DESIGN ADVISORY GROUP #7 / AUGUST 29, 2019

PORTLAND PUBLIC SCHOOLS

BASSETTI ARCHITECTS

GSA VISIT: REVISED RESTROOM DESIGN

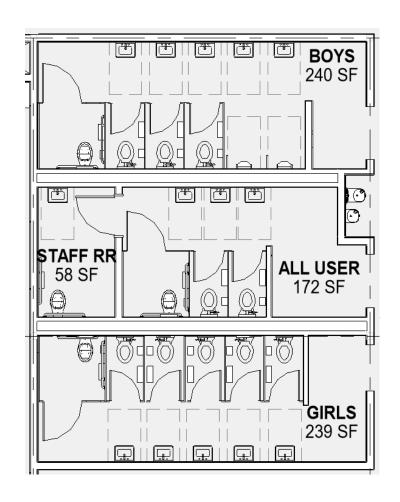
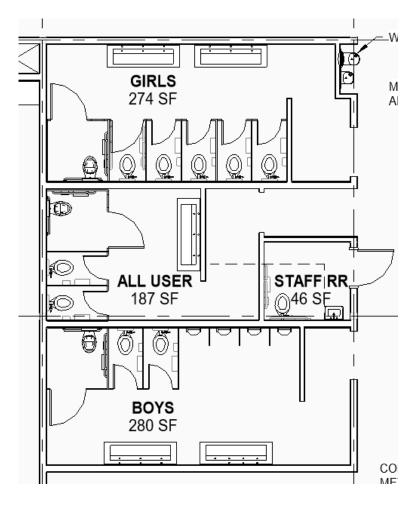
- + New design needs to have all user restrooms that are easy to access, distributed
- + Problem with existing is there are a small number of single stalls
- + Inadequate due to time between classes and trying to find one available
- + Need more single stalls or multi-stall gender neutral (like PCC)
- + In general, need more bathrooms due to inadequate #
- + Signage is needed at all restrooms to communicate other options and their location
- + Single use restrooms need occupancy indicators
- + Restrooms need adequate ventilation
- + Students don't feel comfortable changing in front of others in locker room
- + Need curtained stalls
- + No place for gender neutral students to change
